One Battersea Bridge

Planning Submission Ref: 2024/1322

Whole Life Carbon Review

Thameswalk Residents Association Limited

Figure 4: Decision tree for design approaches for existing structures/buildings

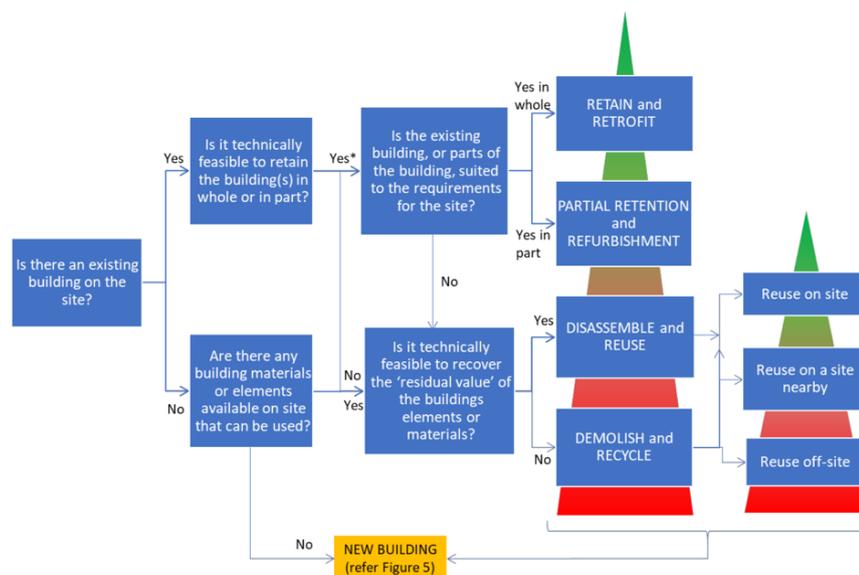
2.7.8 Policy SI7 London Plan Guidance: Circular Economy Statements: Item 2.4.1, page 11, states the following: “The decision tree (Figure 4 below) should be followed to inform the design process for the development from the outset. It should be informed by the pre-redevelopment and pre-demolition audits where possible (see section 4.6 for more information) and WLC assessment, with the outcomes from these aligning”. If this was followed the outcome would be retain and retrofit.
